International Aero Engines
SERVICE BULLETIN

Subject: Transmittal of Revision 2 to Service Bulletin V2500-ENG-79-0067.

**OIL - MAGNETIC CHIP DETECTOR - INTRODUCTION OF A REVISED MAGNETIC CHIP
DETECTOR SUPPLIED BY VICKERS-TEDECO DIVISION**

V2500-ENG-79-0067

Installation of magnetic chip detectors - Before and after alteration
Figure 1

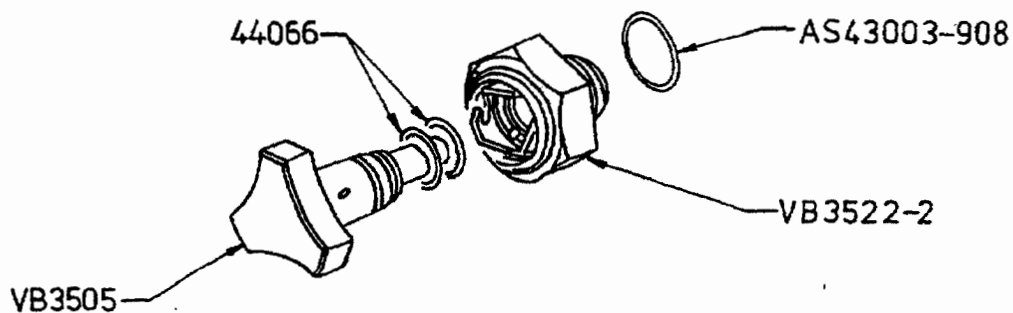
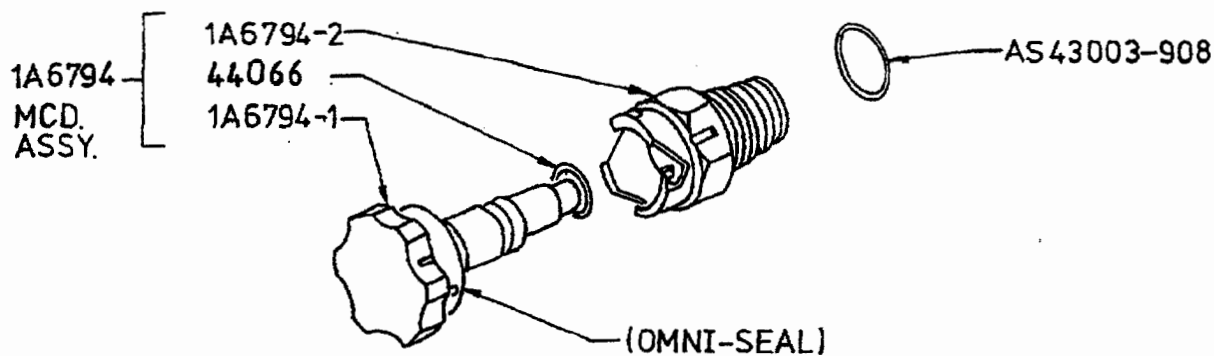
- (1) This Service Bulletin introduces an MCD supplied by Vickers-Tedeco Division (VTD), to replace the Muirhead Vactric Components Ltd standard MCD. The VTD MCD is supplied as a complete assembly. The changes introduced are as follows:

(a) The weight and centre of gravity for the probe have decreased.

(b) The quantity of O-Rings installed on the probe, have decreased from 2 to 1.

- (c) Should the O-Ring introduced at (b) not be installed after maintenance activity, to prevent leaks along the probe a fail-safe Omni-seal is introduced.

- (d) To visually identify the MCD as a bayonet type design, the bayonet groove has been moved from the inside of the housing to the outside.

- (e) The position marks have been changed to make them easier to see.

- (f) The housing has been strengthened and an additional O-Ring has been introduced in the self-closing valve.
